STANDARD FIELD SERVICE BULLETIN

FSB Number	CHRAEFSB2018-10
Author	Tony Bryan
Date	03/23/2018
Subject	Moto C - No Turn On/Charging - Diode Component Damage
Model Affected	XT175x
Level Of Repairs	Level 2

Figure 2.0 - Component Polarity and Placement Location

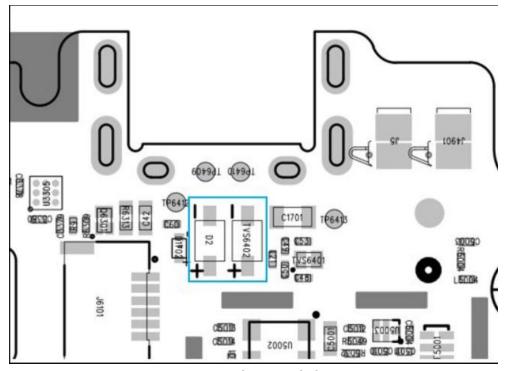
Important Note: The TVS6402/D2 diode component (Part Number: 811210000291 or 811210000292) has polarity (CAN ONLY BE PLACED ONE DIRECTION). Reference Figure 2.0 below.

- a. Per Service Manual, carefully disassemble the device to gain access to the Main PCBA.
 - b. Regardless of seeing TVS6402/D2 diode component (Part Number: 811210000291 or 811210000292) damaged, replace the component as preventative measure to improve overall USB Charging Circuit robustness against electrical overstress.
